Re: Amended Letter of Findings #2, WSSC Project No. DA6736Z19, Shady Grove Innovation Center (Shady Grove Neighborhood Center – Amended Letter of Findings #1)

The amended letter of findings #1 for the Shady Grove Innovation Center project has been amended per your request. This amendment supersedes any previous letter of findings/amended letter of findings. The following changes have been approved:

HYDRAULIC PLANNING ANALYSIS
SHADY GROVE INNOVATION CENTER
ROCKVILLE ELECTION DISTRICT No.4
MONTGOMERY COUNTY, MARYLAND

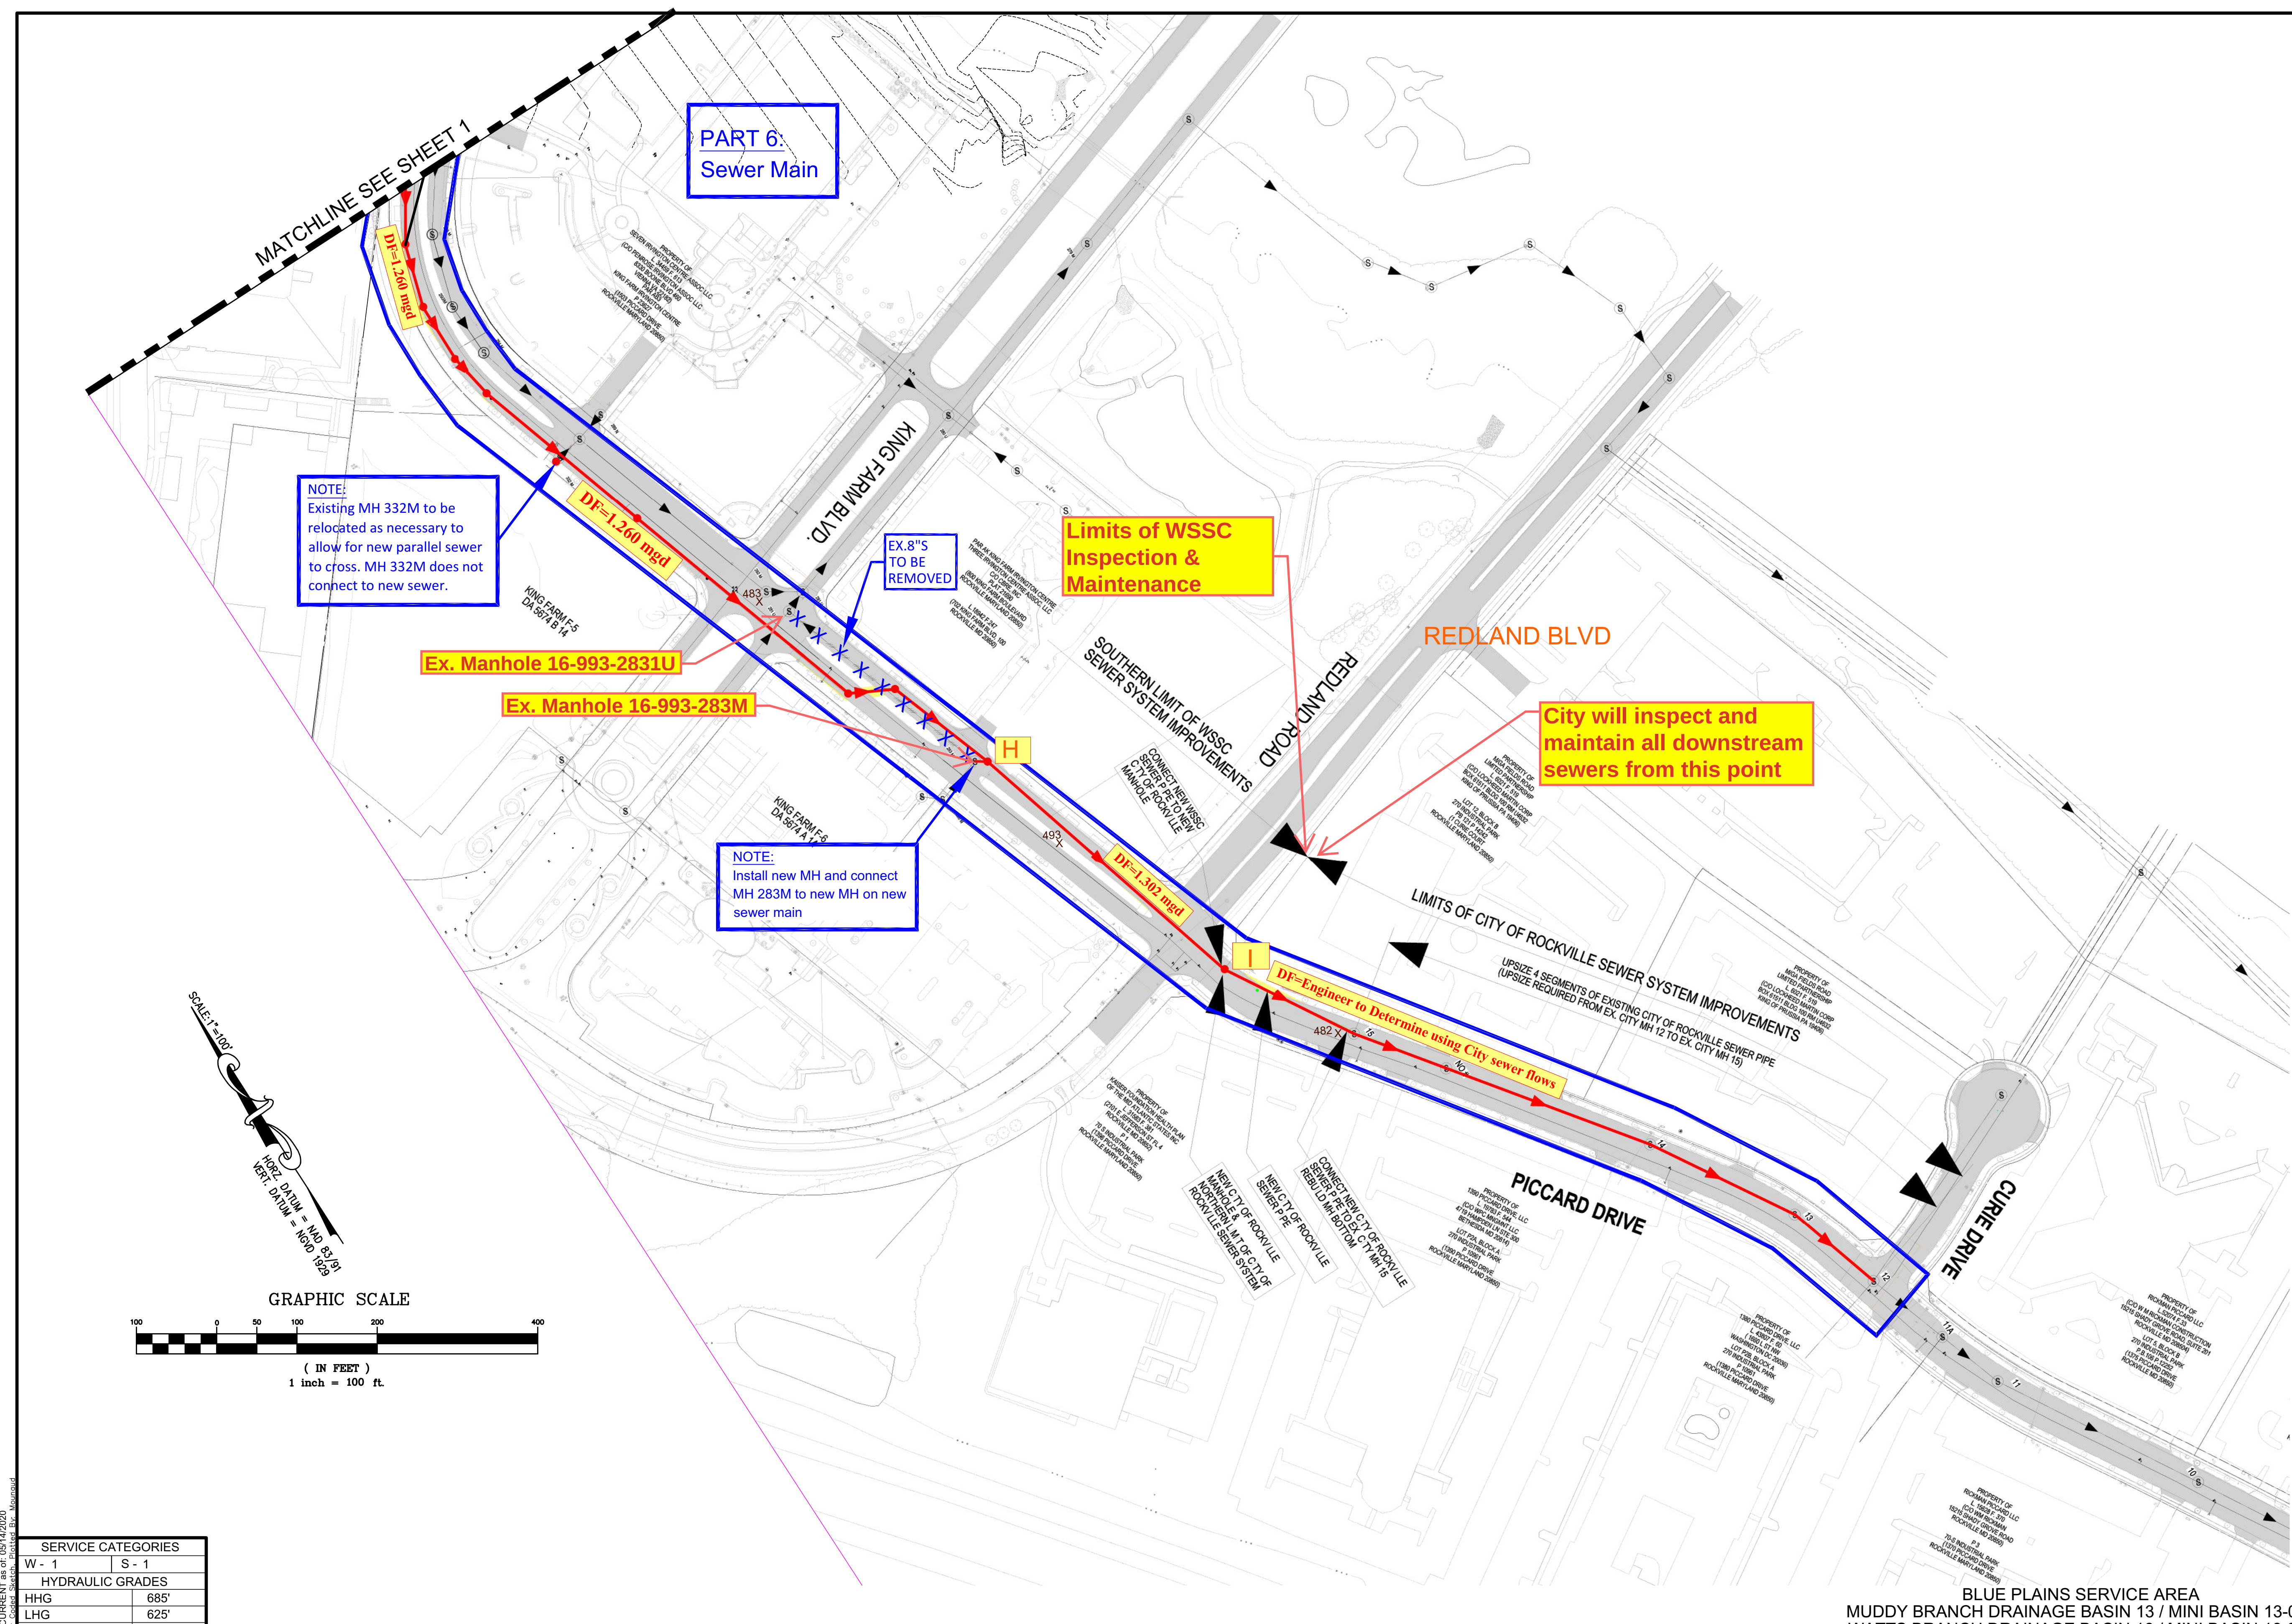
The development will necessitate the replacement and abandonment of existing WSSC facilities. All abandonment should be completed, and easements should be released before starting the new developments (see comments on the sketch in red). Such work and related expenses will be the responsibility of the applicant. The applicant must take all necessary and appropriate steps to ensure continuous and uninterrupted service to existing WSSC customers.

WSSC requires construction of a new 16" water main in Gaither Road. This should be installed in line and grade that would replace existing 16-inch water and aligned the existing 16-inch & 12-inch water main (see comments on sketch in red). Water service to this project is dependent on the existing 16" water main to be in service at all times.

Design flow for gravity sewers having capacity greater than an 8-inch sewer at minimum slope are shown on the attached sketch and table below. All other sewers shall be 8-inch in diameter.

As shown on the attached sketch, replacement of a downstream sewer between ex. manhole # 16-993-281U located at the crossings of King Farm Blvd and Piccard Drive and downstream manhole # 16-993-283M located in Piccard Drive is necessary to provide sanitary sewer service for Part 5, Phase C, and Part 7 (all Phases) of your property. Design flow for the replacement sewer is 1.260 mgd. The design flow for sewer downstream of ex. MH 16-993-283M (section HI see approved HPA sketch #2) is 1.302 mgd (see table above). All downstream sewers from proposed MH I (labeled on approved HPA sketch #2) should be designed using WSSC flows plus any flows (existing and proposed) from City's jurisdiction. Provide continually increasing sewer pipe sizes running downstream. Sewer sizes must meet the requirements outlined in the latest approved WSSC Pipeline Design Manual. The cost for this work will be borne by the applicant.

This project will be served by more than one sewer system minibasin. Design plans that encompass more than 1 minibasin should indicate the boundary as shown on the attached sketch.

The diameters of the proposed mains, **4, 8, 10 and 16 inches**, are shown on the attached sketch.

main. See the sketch for preliminary locations of isolation valves. Keep valves *Open*. Numbers and exact location of valves will be determined during the Design phase.
